PROJECT **123A90 - HOLLANDSE KUST NOORD WIND PARK**
BLPH Project

MECHANICAL COMPLETION DOSSIER (ONSHORE)

SYSTEM	70 Safety and Facility Systems
SUBSYSTEM	70-00-27 Junction Box 950-JE-04207 and Multi-core cable (FGS System)

C30001085

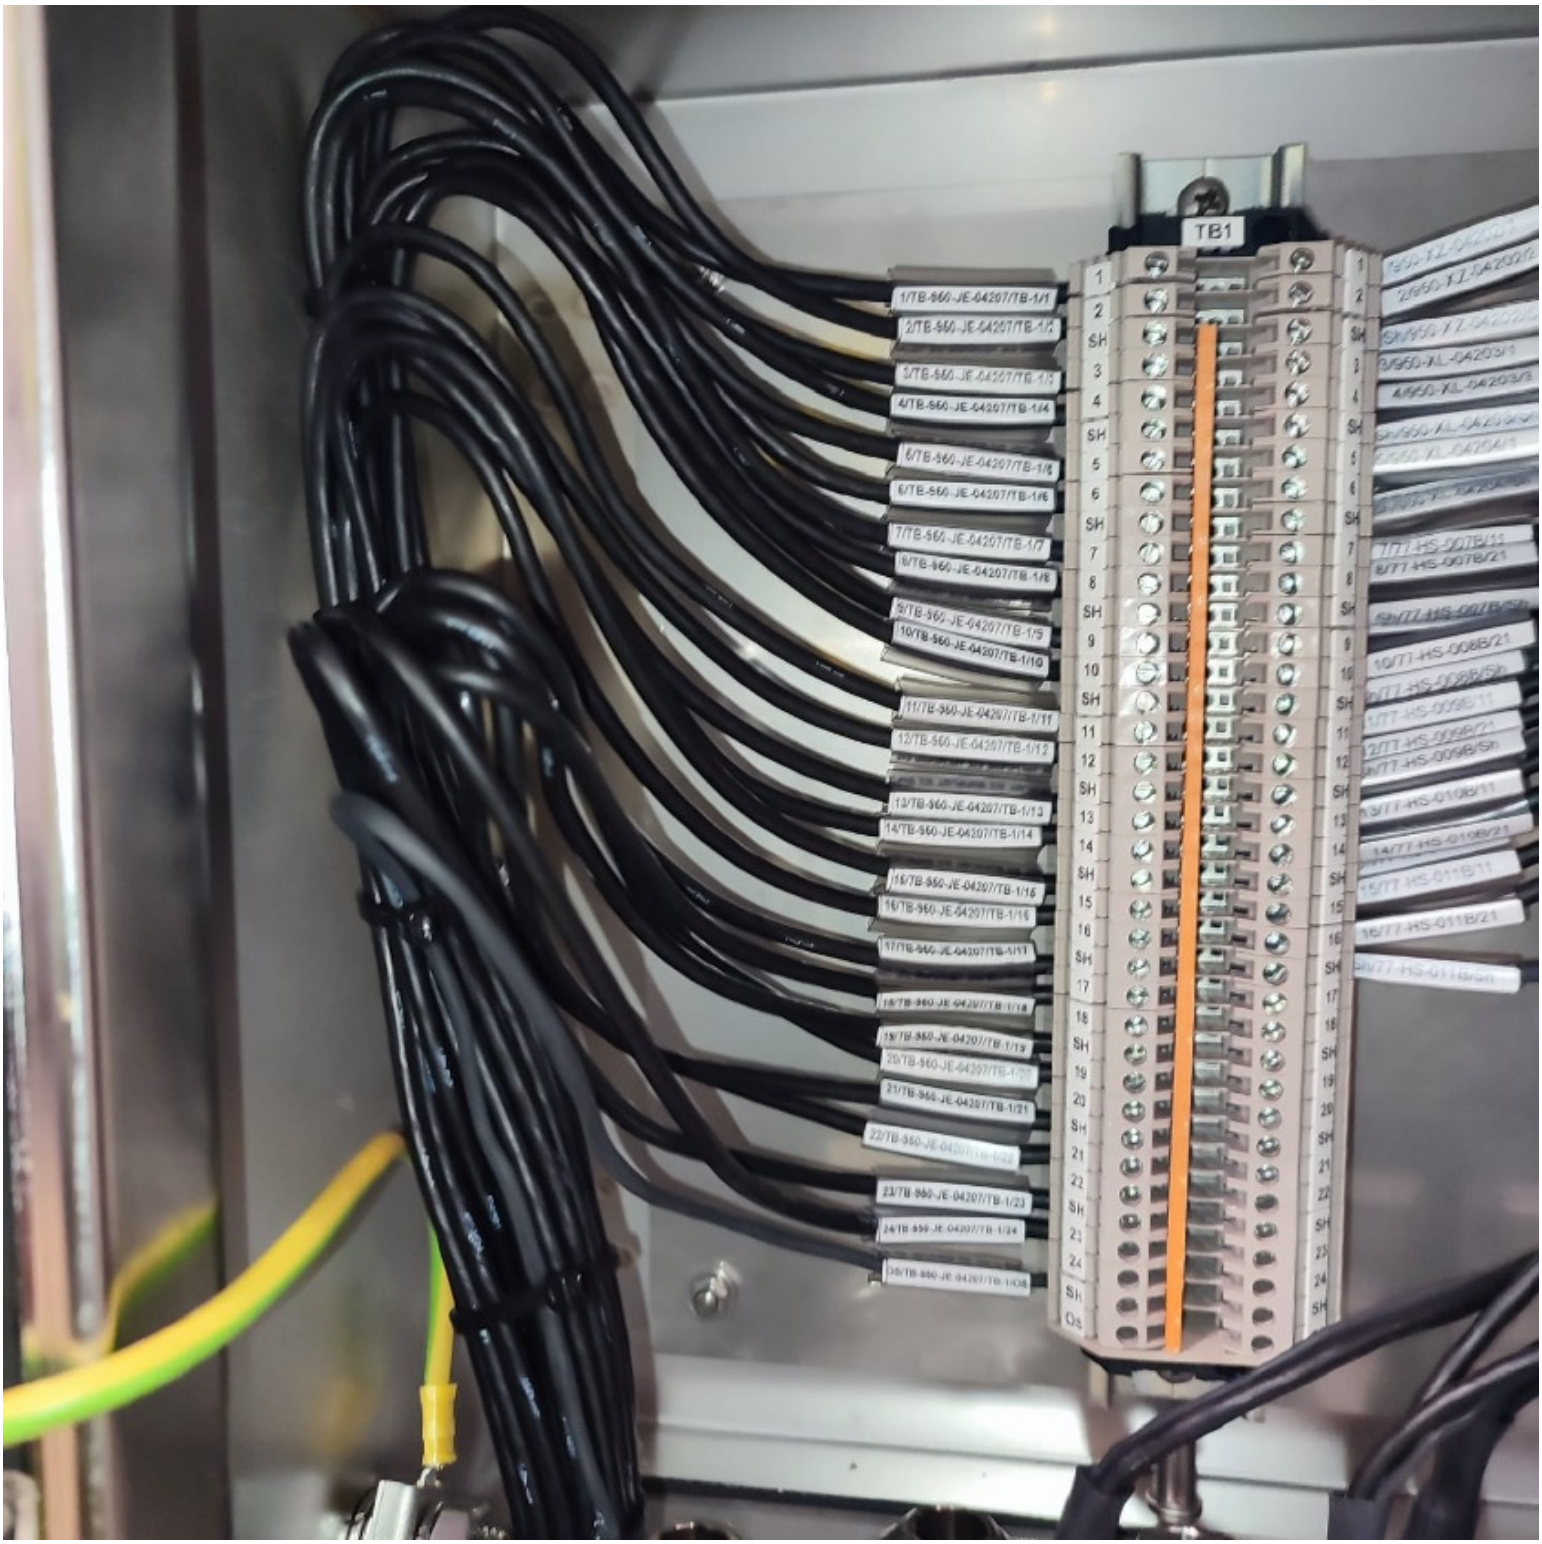
the cable is not connected as indicated by wiring diagrams (document 123A90-DDL-IN-DG-40016 sh.69.)

closed.

C30001072

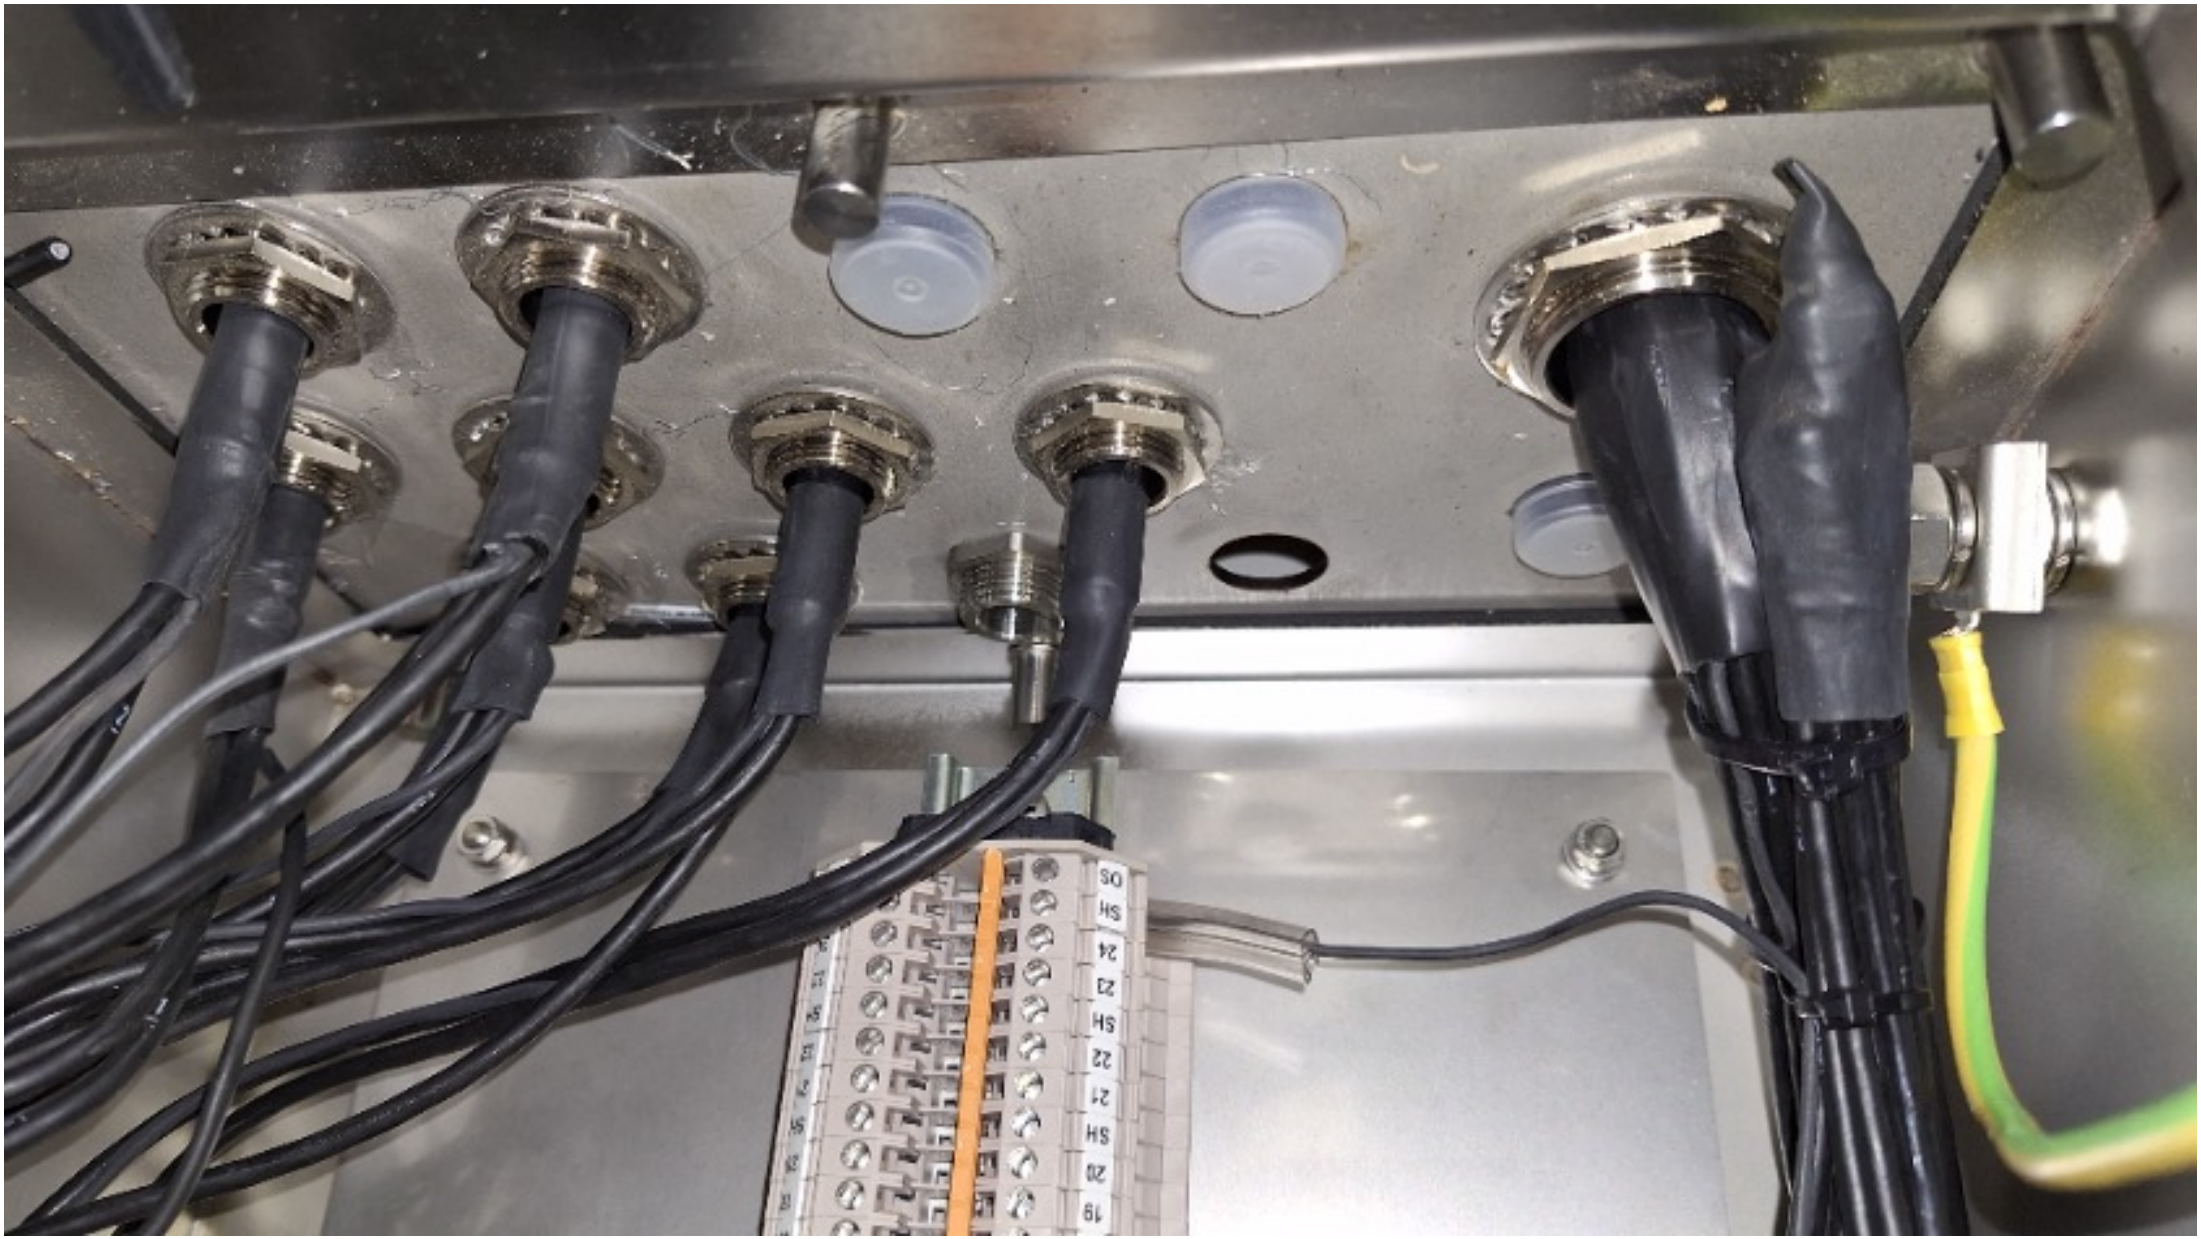
The unused entries "are not plugged" with approved blanks.

DONE

C30001075

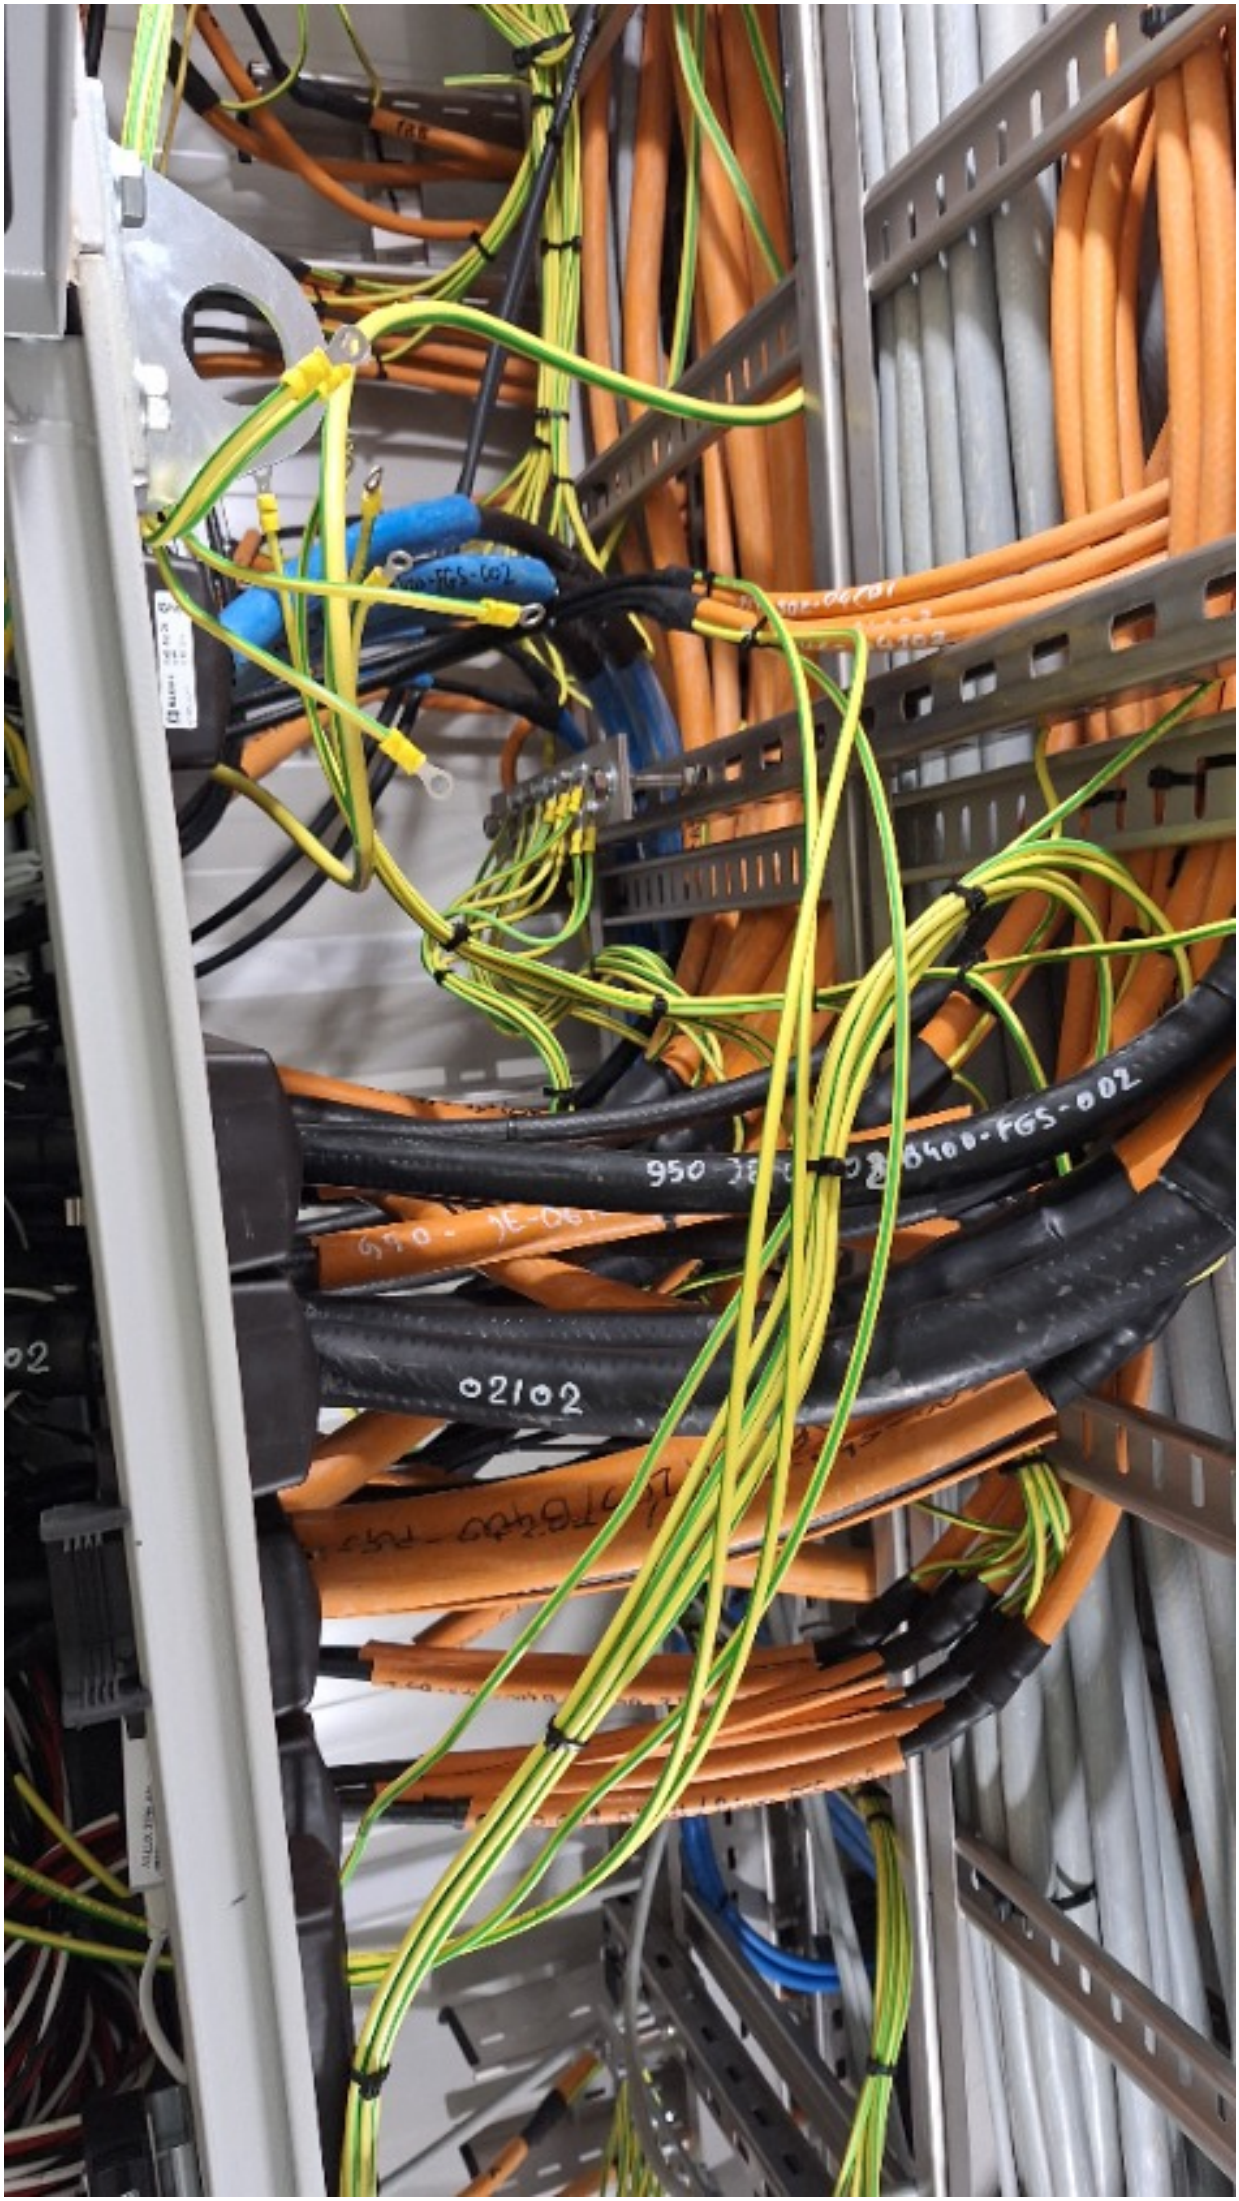
Missing cables tag , cabinet side B400-FGS-002 / JB 950-JE-04207

DONE

C30001077

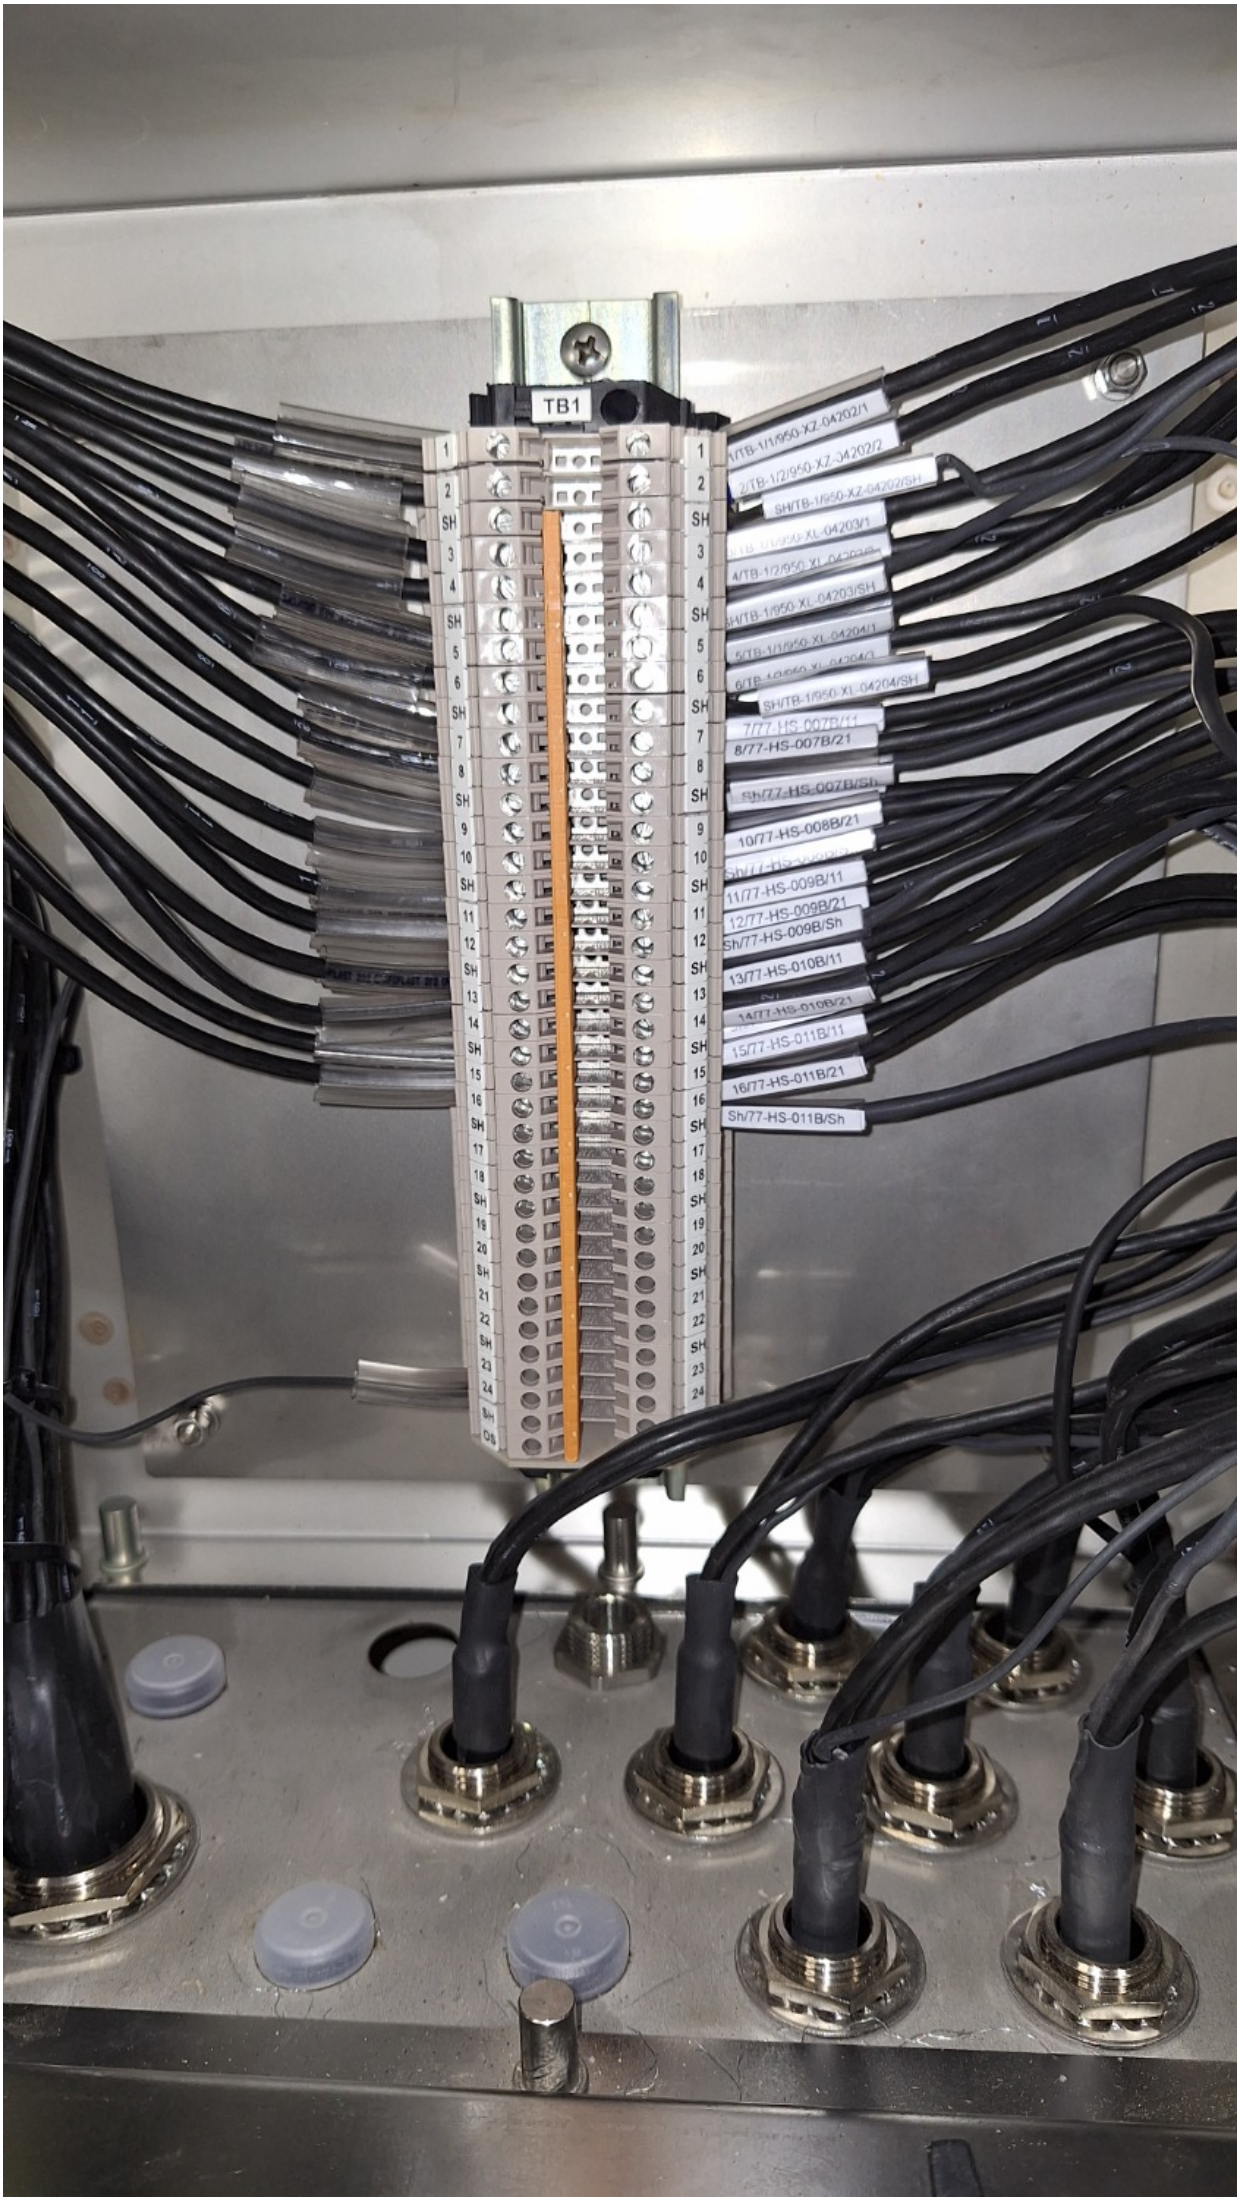
Missing the cross-ferruling (Cores) . Cabinet side B400-FGS-002 / JB 950-LE-04207 . (see document 123A90-DDL-IN-DG-40016 sh.3)

DONE
